FCC ID : NTMEJ8LT-WT480T

Explain of Q2 of Correspondence Reference Number 20823

15KHz modulation

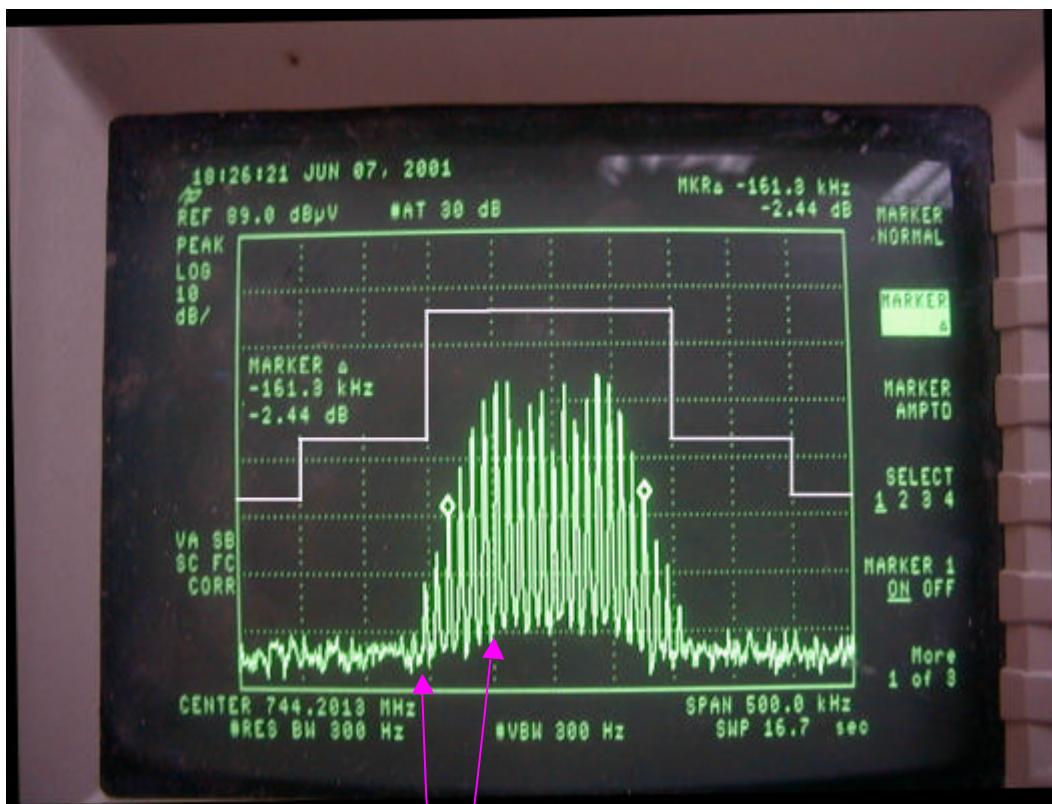
Firstly, the page 31 of report is actually for 15 KHz. Because, the EUT is including tone frequency 38kHz when unmodulation then input 15 kHz signal by signal generator..

Finally, The EUT produced harmonics of 15 kHz (For example 15 kHz, 30 kHz, 45kHz and so on) and harmonics of tone frequency 38 kHz (For example 38 kHz, 76 kHz, 114kHz and so on). See next page.

Above status produced wrong messaged to sidebands spaced at 10 kHz

If you not accept this explanation. I can do 10kHz modulation provable next page corrected.

The sidebands spaced is including the 15kHz and all harmonic frequency with 38 kHz tone frequency
